# Site monitoring report

**Site Name:** Highwood Quarry, Stortford Road, Little Canfield

**Date:** 27 March 2024

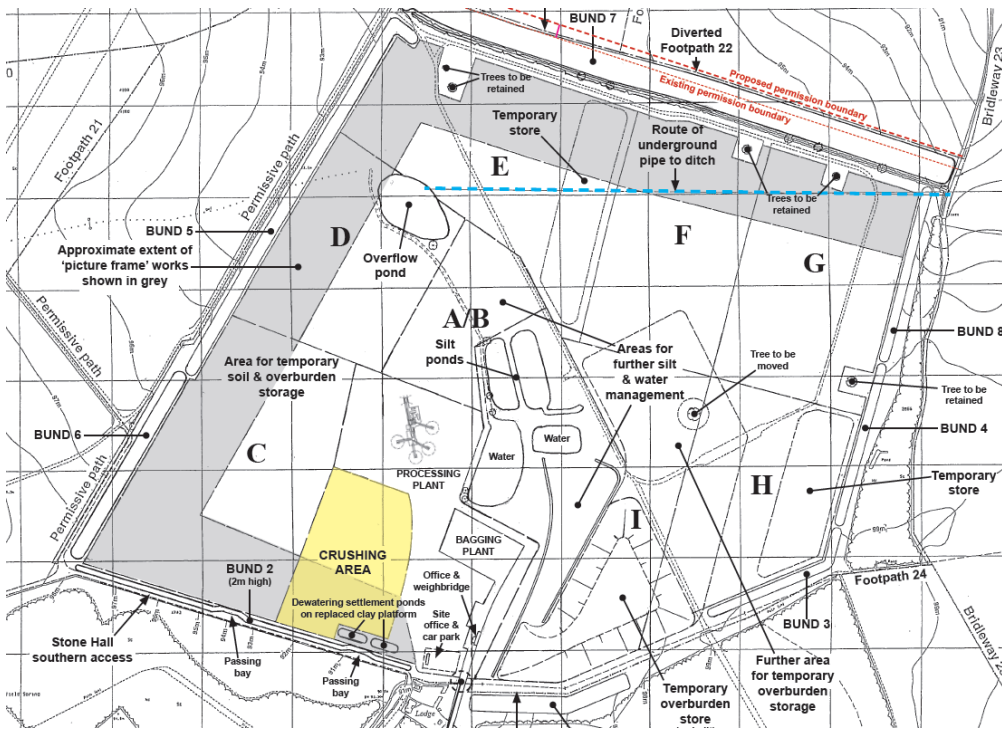
Extraction completed on NW section of access track, EQA report sent to EA re lining of site for boundary of D and E.
